Re: Proposed Townhomes at Woodbank 0 Warburton Avenue

As the Architect representing PTG Development, LLC, owner of 0 Warburton Avenue, I am submitting the attached revised drawings, dated May 4, 2017, describing six new townhouses at 0 Warburton Avenue, for site plan, view preservation, and steep slopes review. Our submission consists of the following drawings:

In response to comments made by the Planning Board at the meeting on March 16, 2017, the drawings were revised, and additional drawings were prepared, as follows:

PLANNING BOARD SUBMISSION 12-15-16
PLANNING BOARD SUBMISSION 3-2-17
PLANNING BOARD SUBMISSION 3-1-17
REVISED PLANNING BOARD SUB. 5-4-17
REVISED PLANNING BOARD SUBMISSION 3-1-17
REVISED PLANNING BOARD SUBMISSION 12-2-17
REVISED PLANNING BOARD SUBMISSION 3-1-17
REVISED PLANNING BOARD SUBMISSION

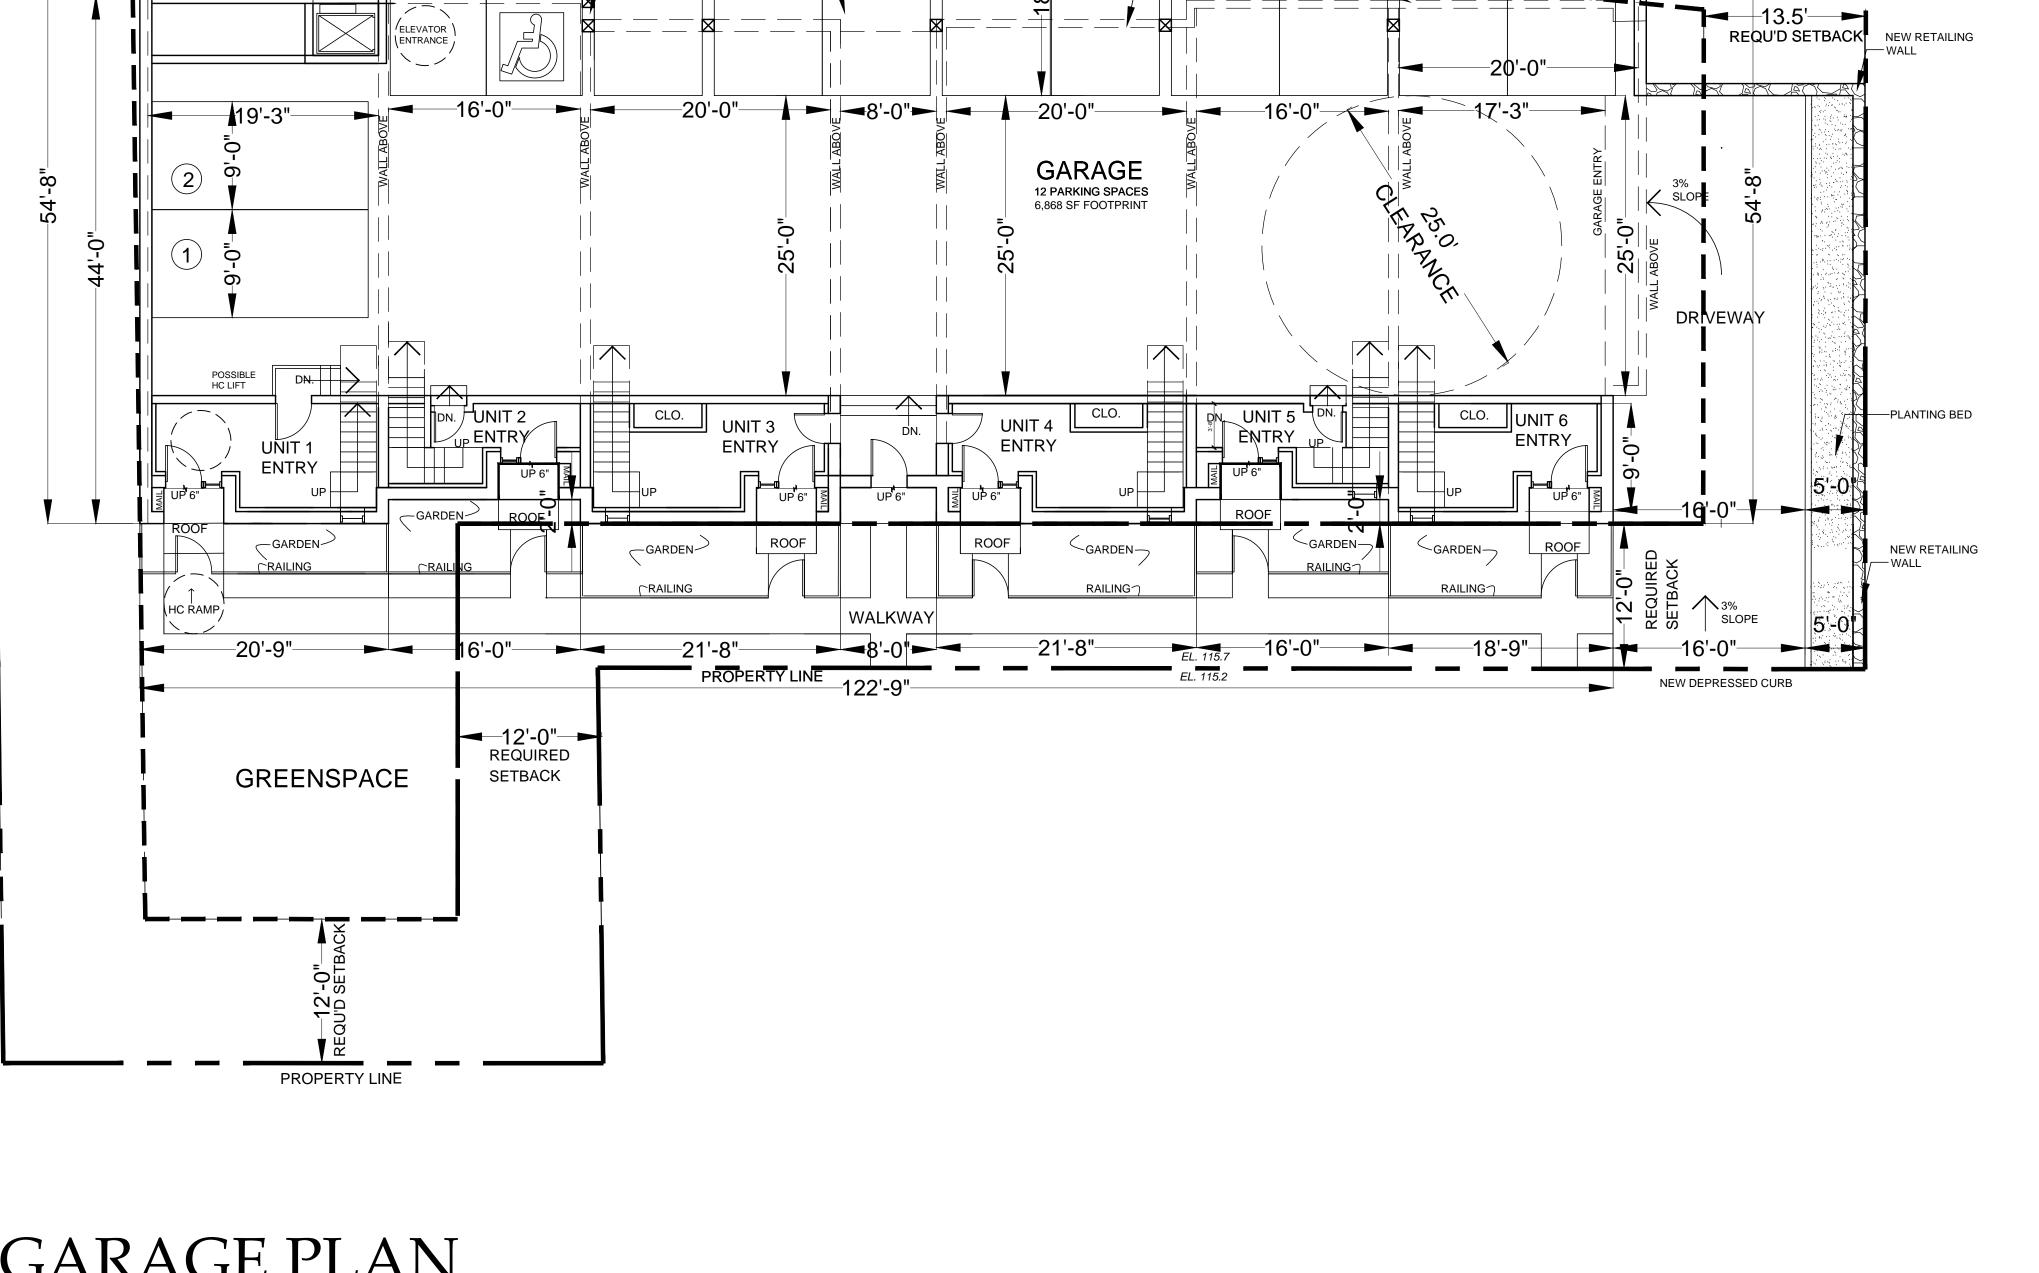
- 2. The development coverage has been reduced to 37% from 46%, as a result of lowering the building so that the garage is below grade, and eliminating the roof decks at the rear vard. The street elevation has been established at elevation 112.6, and as a result, we were able to lower the first-floor level. This street elevation will facilitate the design of a storm water drainage system, since the 112.6 elevation is a low point of the street, and allow the retaining walls of neighboring properties to remain. See Site Plan, Drawing S-2.

THIRD FLOOR PLAN

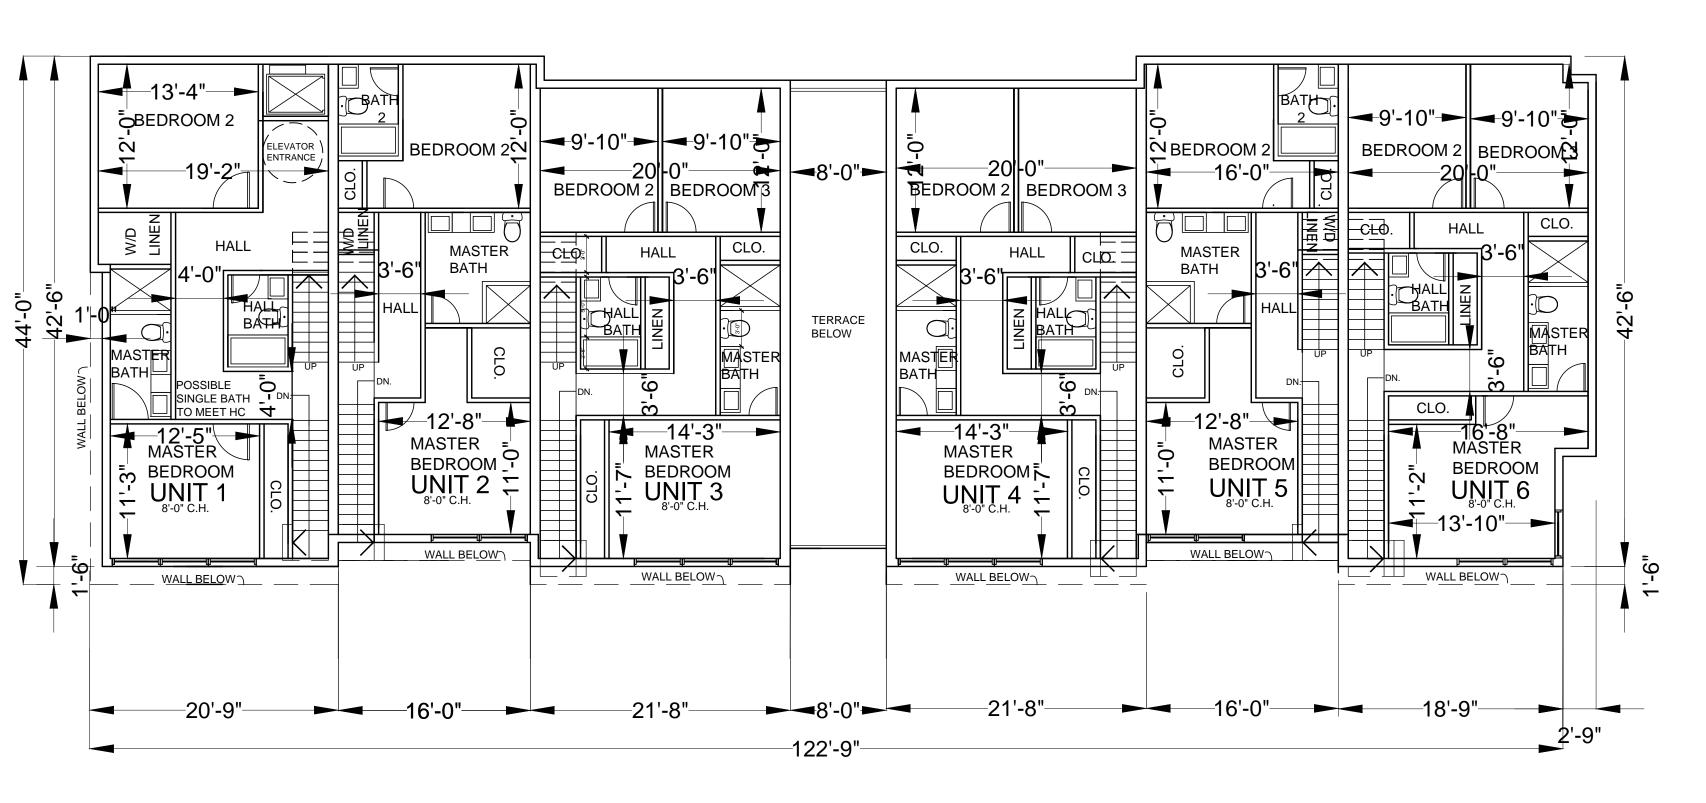
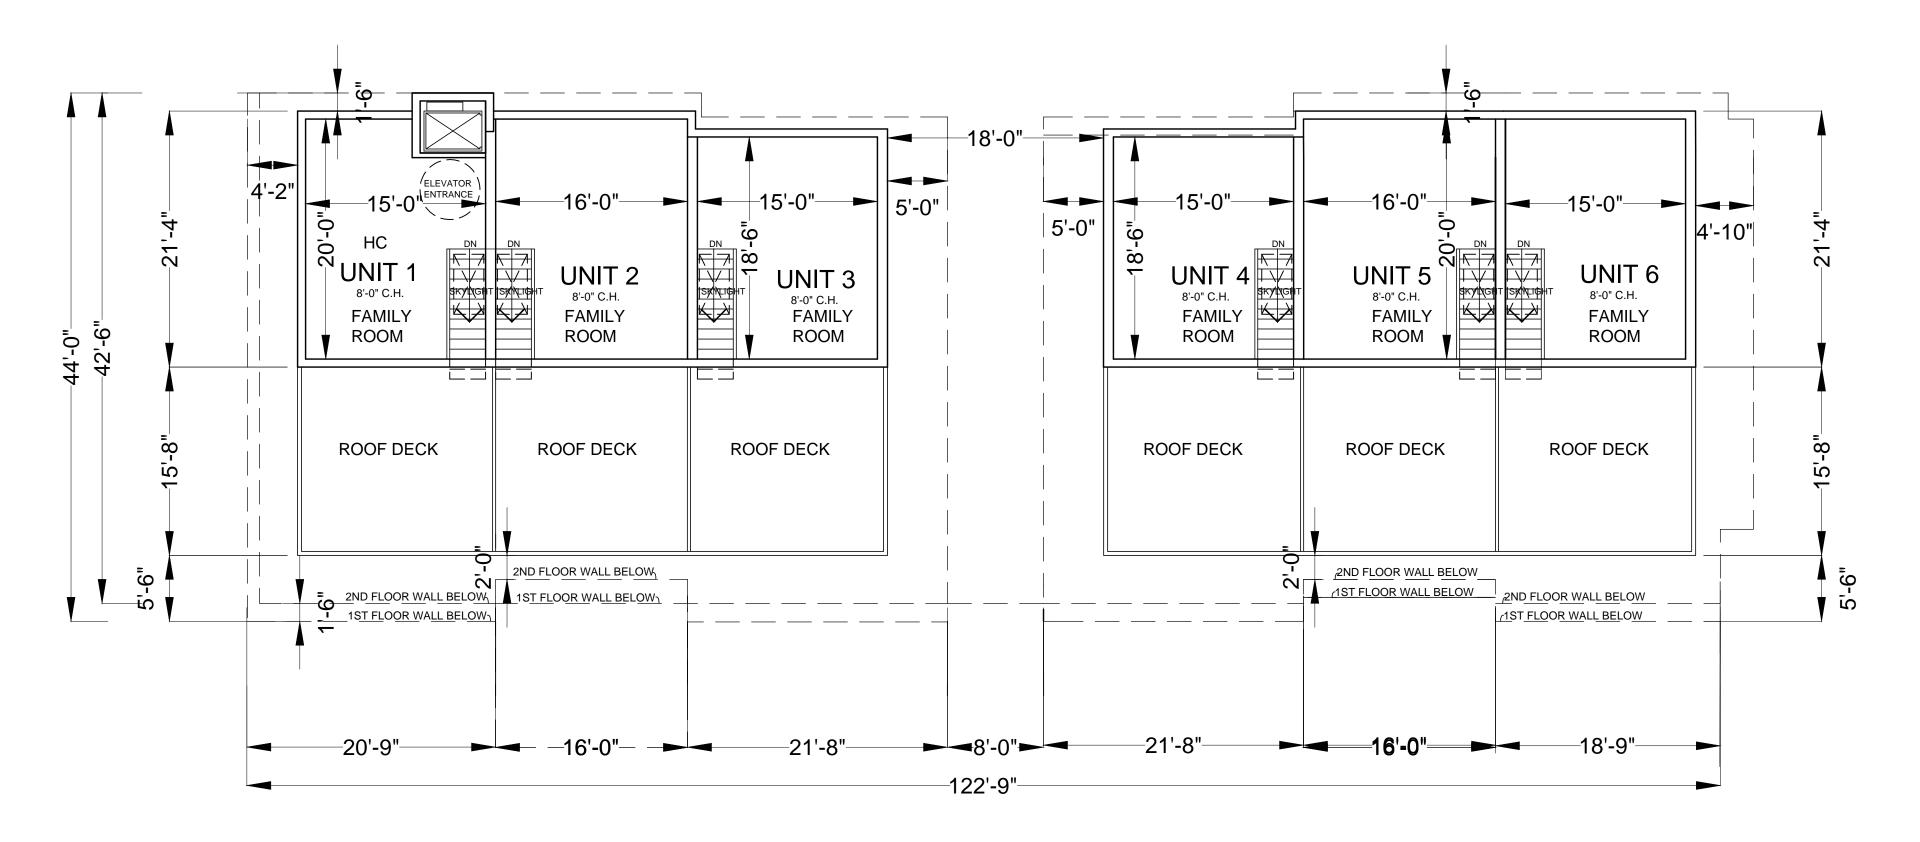
- 6. The total area of the third floor has been reduced to 1,804 SF from 1,976 SF, which reduces the mass of the building and impact on views. Also, the third floor has been pushed towards the rear yard to open up views from the OCA over the building. See Drawing A-3.
